# UNITED STATES PATENT AND TRADEMARK OFFICE

APPLICATION NO.	FILING DATE	FIRST NAMED INVENTOR	ATTORNEY DOCKET NO.	CONFIRMATION NO.
10/063,088	03/18/2002	Michael G. Cousin	1202.03	6422

## Office Action Summary

## **DETAILED ACTION**

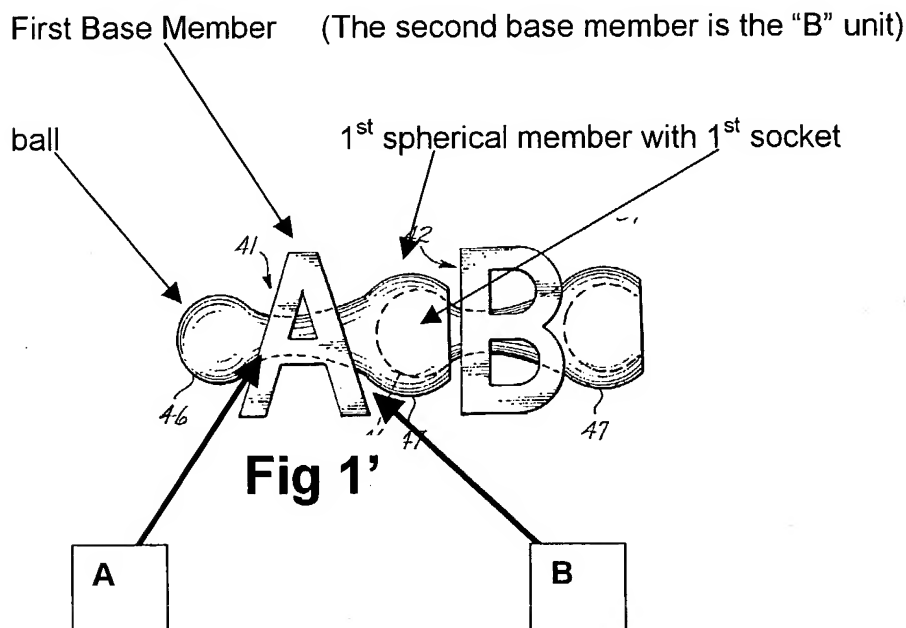
Re claim 10: Miller discloses a pop bead construction in combination with a first (41) and second base (42) member comprising:

a first truncate neck (A in Fig. 1' - See examiner's Fig 1' below.) extending from a first side of said first base member at an upper end of said first base member; a ball (46) formed in a distal free end of said first truncate neck; a second truncate neck (B in Fig. 1' - See examiner's Fig 1' below.) extending from a second side of said first base member (41) at an upper end of said first base member, a first spherical member formed on said second truncate neck at a distal free end thereof; a first socket formed in said first spherical member, See Fig. 7 of Miller; a third truncate neck extending from a first side of said second base member at an upper end of said second base member; a ball formed in a distal free end of said third truncate neck; a fourth truncate neck extending from a second side of said second base member at an upper end of said second base member; a second spherical member formed on said fourth truncate neck at a distal free end thereof; a second socket formed in said second spherical member; said second socket adapted to releasably receive said ball formed in said distal free end of said first truncate neck; said first and second truncate necks and said first socket being formed in said first base member at said upper end thereof so that said first base member depends from respective innermost ends of said first and second truncate necks; said third and fourth truncate necks and said second socket being formed in said second base member near said upper end thereof so that said second base member depends from respective innermost ends of said third and fourth truncate necks; each of said first and second base members formed in the shape of a symbol; whereby a chain

of symbols is formed when said ball formed in said distal free end of said first truncate neck is in engaging relation to said second socket formed in said second spherical member. See Fig 1' below.

However, Miller does not teach that the truncate necks are of a uniform diameter along their necks. Charles teaches a pop bead with a uniform diameter truncate neck in Figs. 1-7. Note that Fig 4 and col 2 lines 47-56 shows a pop bead assembly with a very elongated separate truncated neck with balls on both ends adapted to connect to beads with sockets with cavities on both ends, interchangeable with the pop beads having both a socket and a truncate neck on the same bead, and shows multiple beads, each with a truncate neck and socket, strung together in Fig 7. Therefore, as customary, it would have been obvious to one having ordinary skill in the art at the time the invention was
